## **GROVE FARM**

### **TRANSPORTATION & HIGHWAY WRITTEN REPRESENTATIONS**

**HIGHWAYS ENGLAND  
DEVELOPMENT CONSENT ORDER APPLICATION (DCO)  
FOR  
M25, JUNCTION 28 IMPROVEMENT SCHEME**

**Redwood Reference: PMcL/3396d1/Feb 2021**

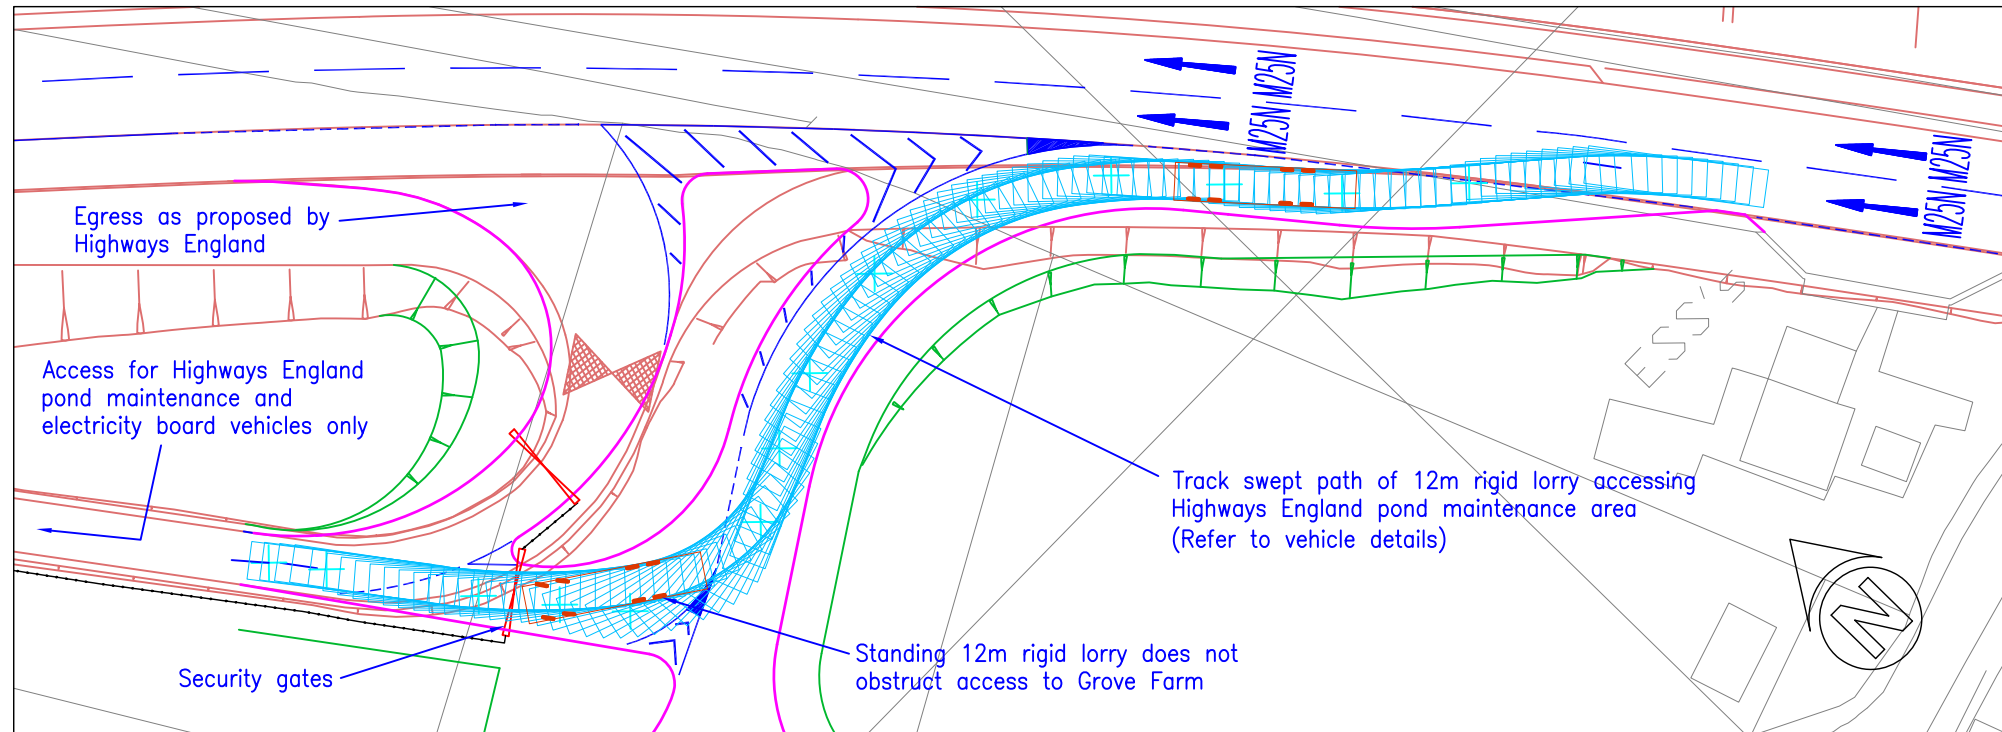
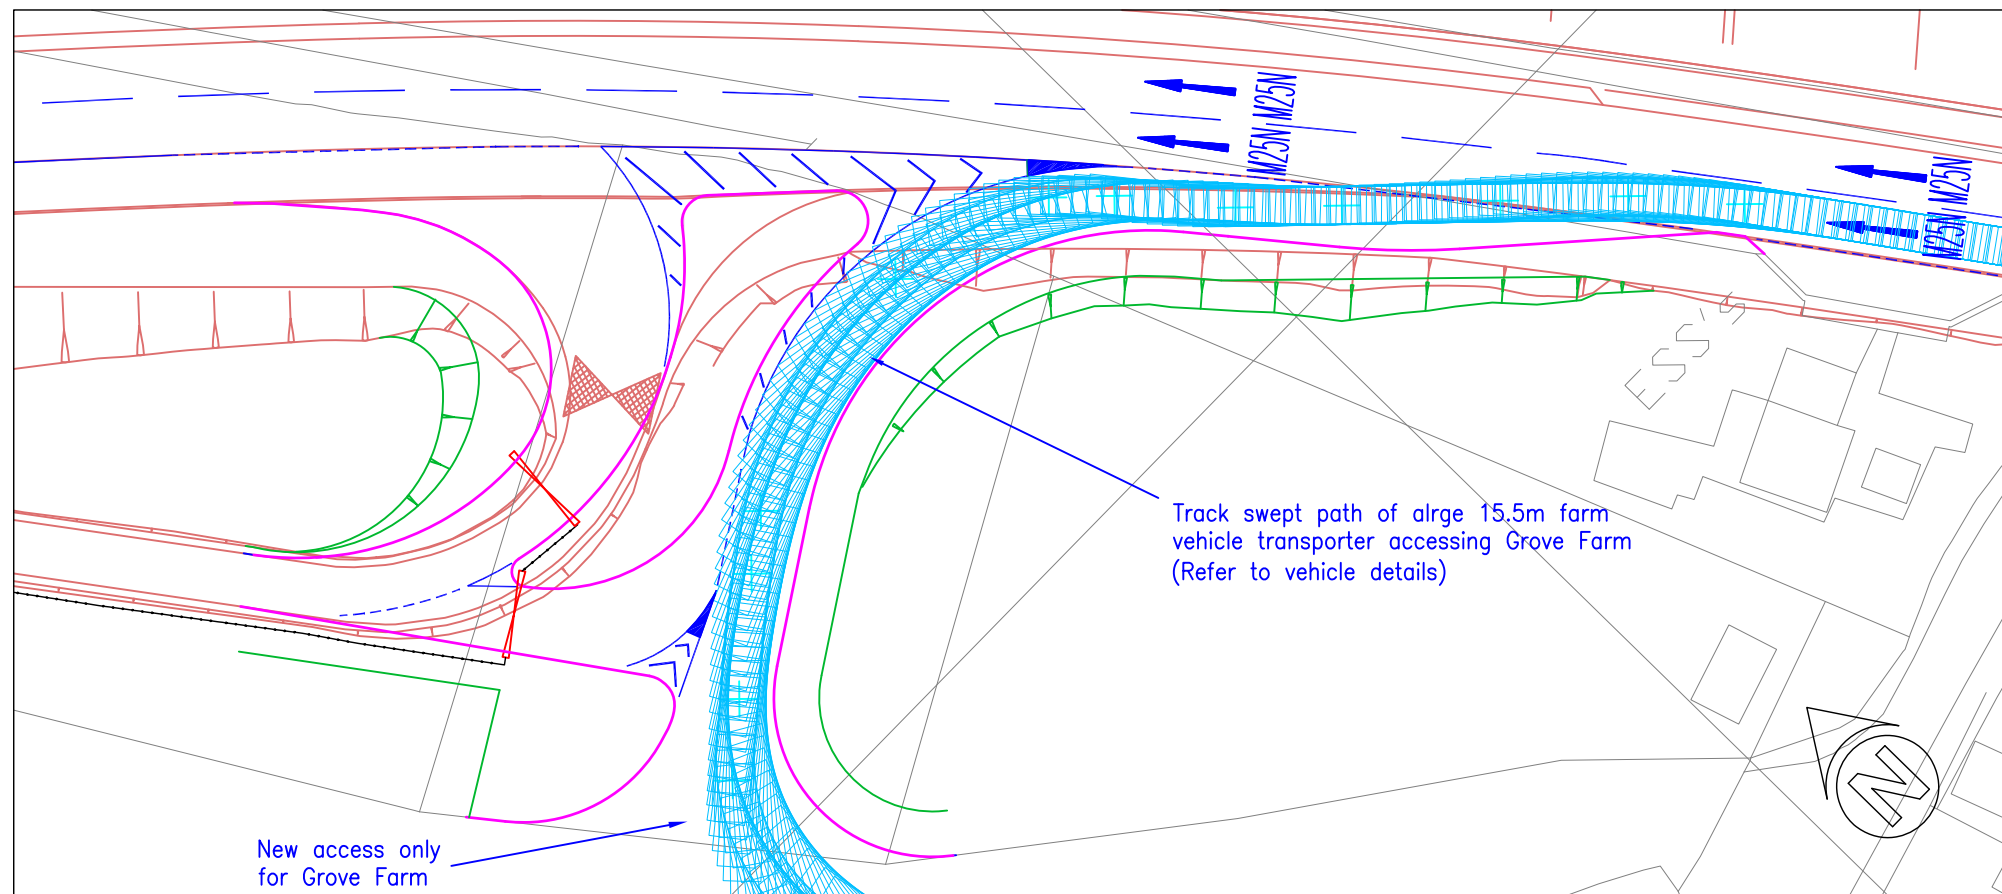
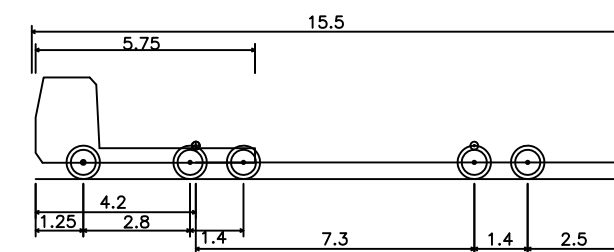
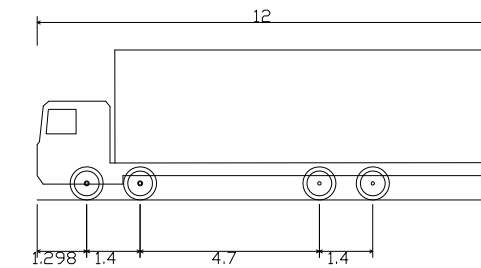
- 2.10 The design of the proposed relocated Grove Farm access caters for the largest of vehicles likely to access Grove Farm and its associated uses. My **Drawing No. REDW-3396-113** (bottom panel) shows the track swept path of a 15.5m long farm vehicle transporter leaving the M25 northbound on-slip and safely turning into the site. During our discussions with Atkins, it was stated by them that they would be concerned about vehicle delay and potential tail-back of vehicles accessing the pond maintenance area with vehicle entering Grove Farm. An additional concern of Atkins was that HE needed to maintain site security of the pond maintenance area.

- 2.11 To address these security and safety issues my **Drawing No. REDW-3396-113** (top panel) shows the track swept path of a 12 metre rigid lorry leaving the M25 northbound on-slip and safely turning into the access road leading to the pond maintenance area in advance of the security gates. A 12 metre rigid is significantly larger than the longest vehicle expected to access the pond service area. The track shows that this vehicle can turn into a dedicated waiting area in front of the security gates without obstructing traffic entering Grove Farm.

Client MR L JONES & MRS K JONES			Project GROVE FARM ACCESS, JUNCTION 28 M25 NORTHBOUND SLIP LANE			
			Title HGV ENTRY AT PROPOSED NEW ACCESS TO GROVE FARM			
Status FOR APPROVAL	Drawn PL	Scale 1:500	Sheet Size A3	Date JAN 2021	Drawing No. REDW-3396-114	Rev

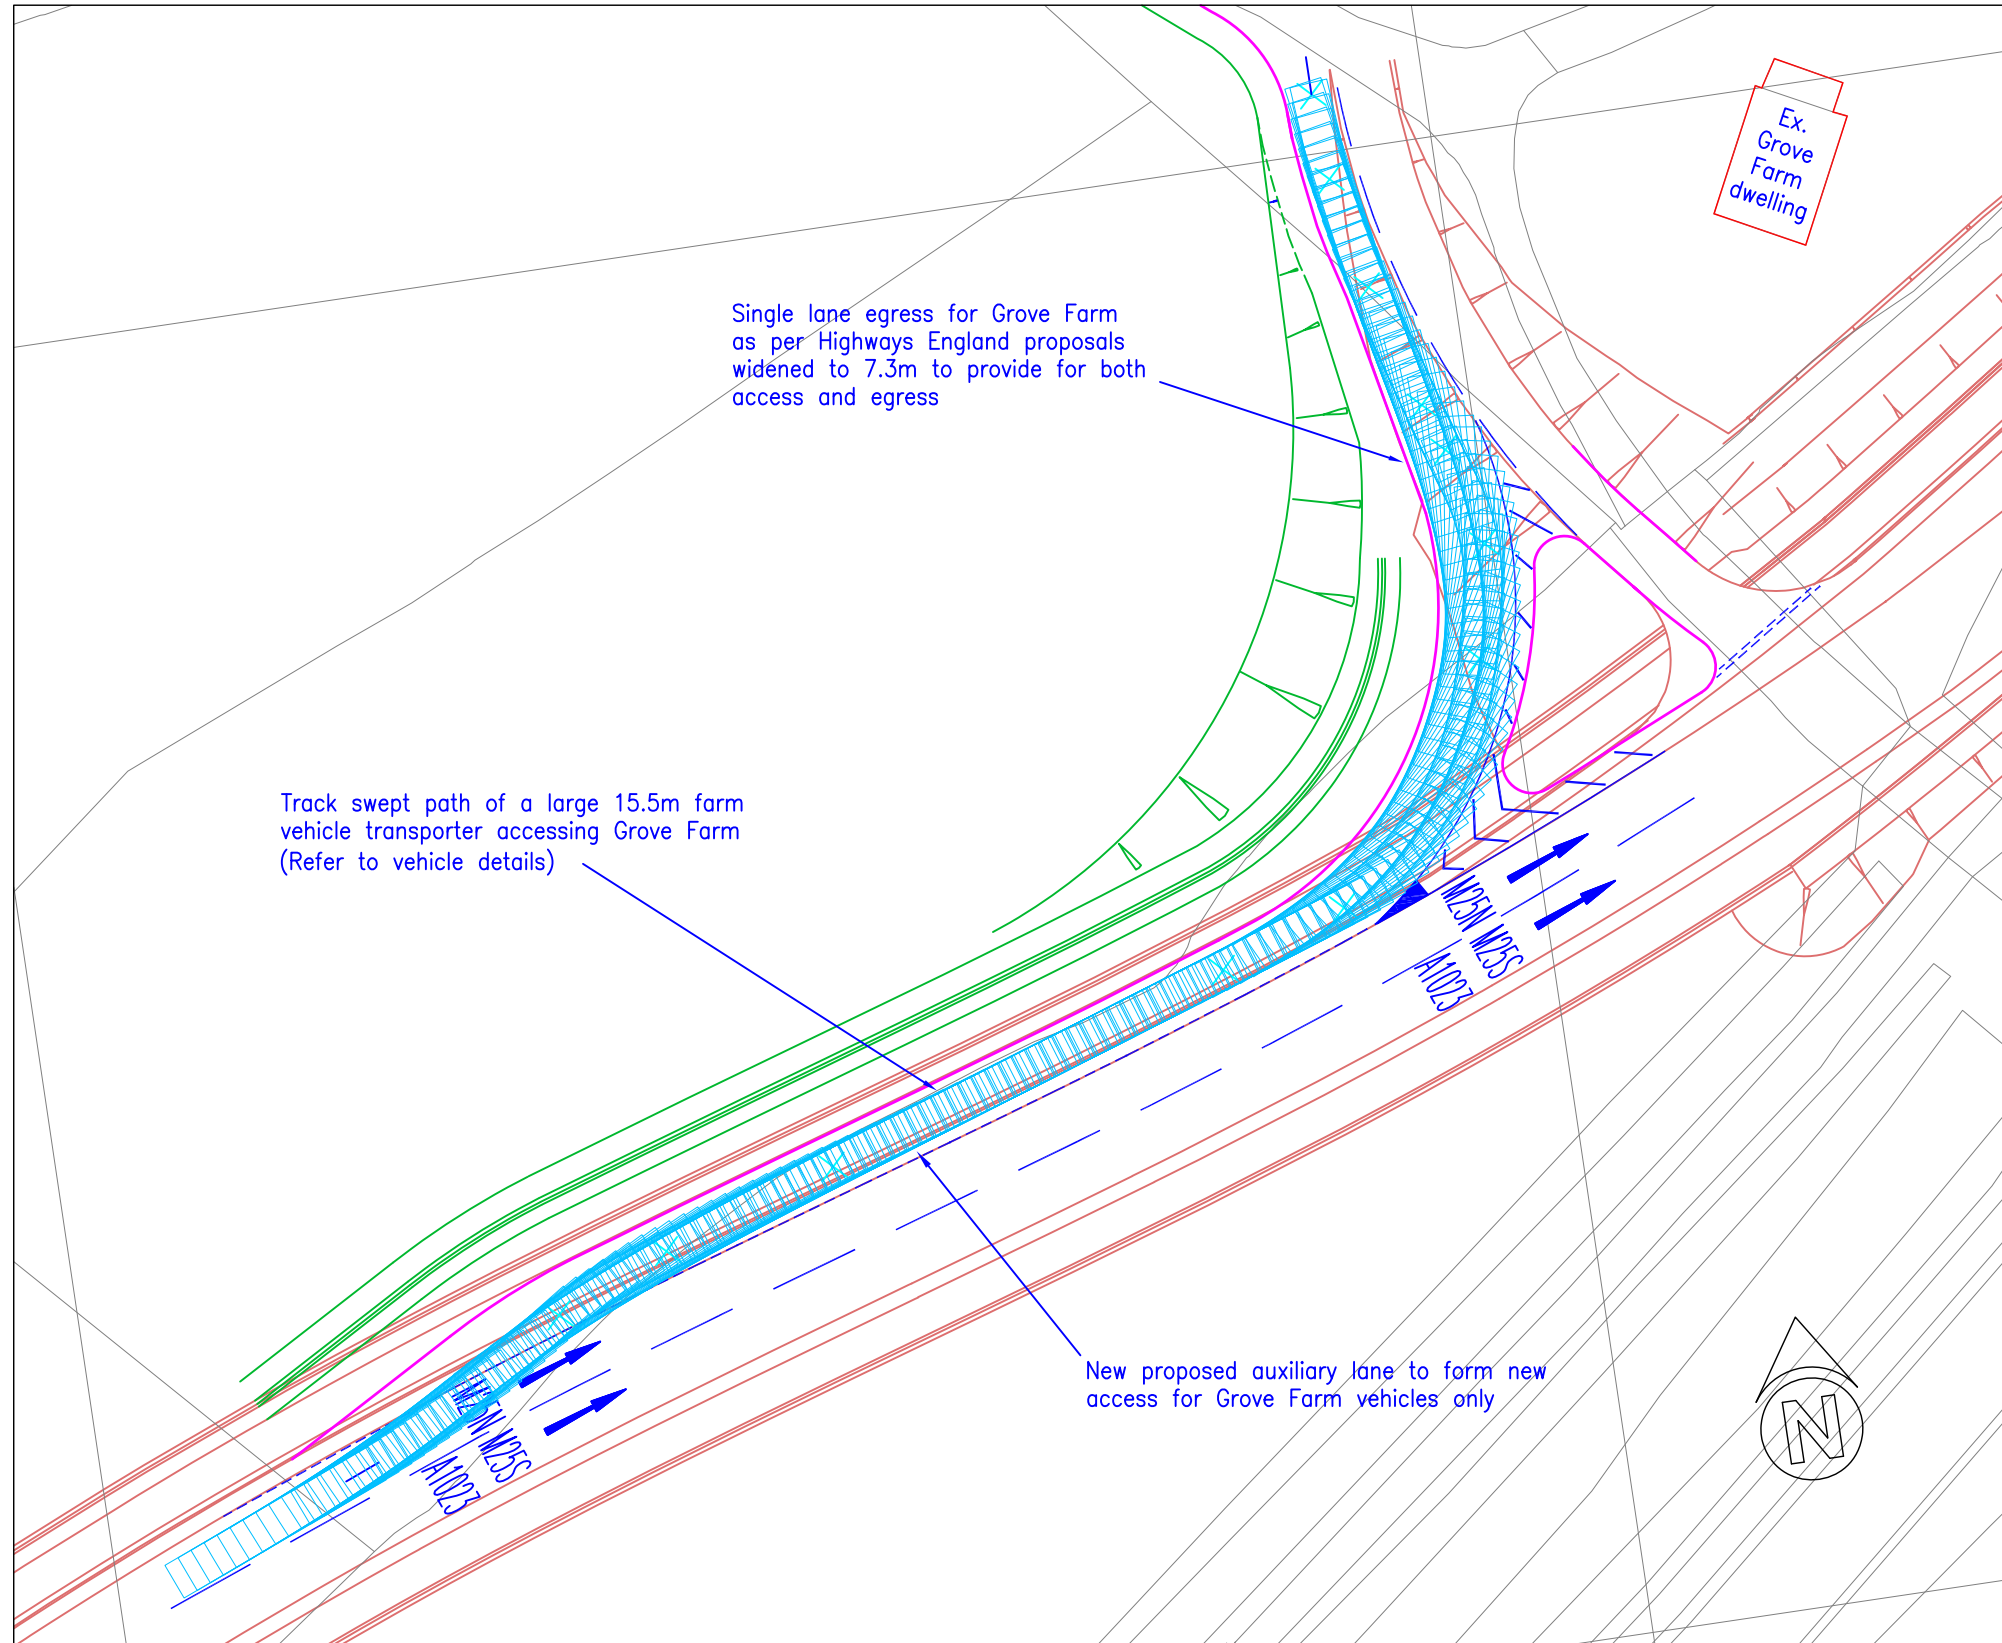
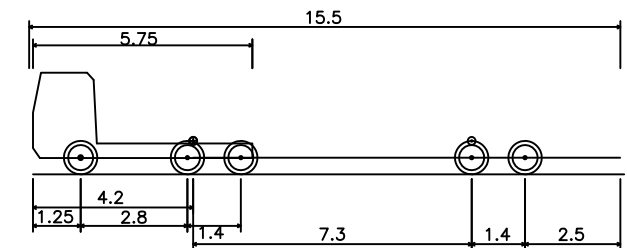
- 3.5 The design of this new Grove Farm access caters for the largest of vehicles likely to access Grove Farm. My **Drawing No. REDW-3396-114** shows the track swept path of a 15.5m long farm vehicle transporter leaving the A12 eastbound off-slip and safely turning into the site. All traffic accessing the site from this direction will be removed from the roundabout.

The swept path analysis provided detail the path of a 15.5m long articulated vehicle with a two-axle trailer. During the site inspection, tractor units towing 3 axle trailers were observed entering/egressing the site. Whilst the proposed highway arrangement may be sufficient to accommodate larger vehicles, this should be checked and confirmed.
